Access Compliance Report Public Rights-of-Way (Curb Ramps)

Main Street: DODGE_AVE Cross Street: SANDHURST_PL Location: NW

ADA ID: RPAT211019131546 Ramp Type: Type 1 - Perpendicular Diagonal Initial Pass/Fail: Pass Overall Compliance: No Severity Score: 4

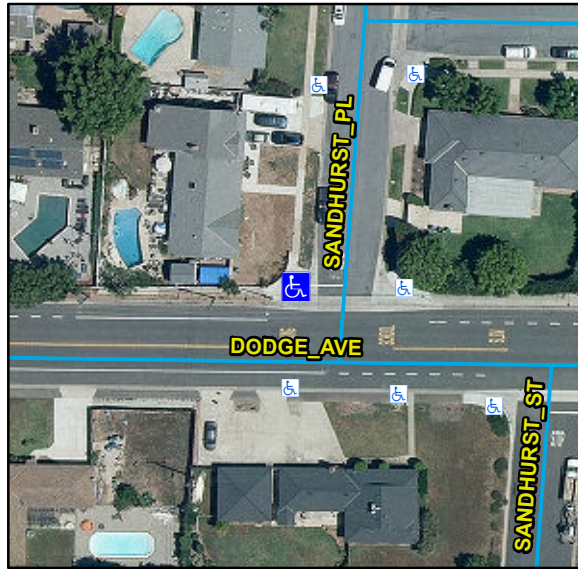
R304.2.2, R304.2.1, R304.5.3, STD 1115

Remove & Replace Curb Ramp With Two New Directional Ramps or Equivalent. Remove & Replace Gutter.
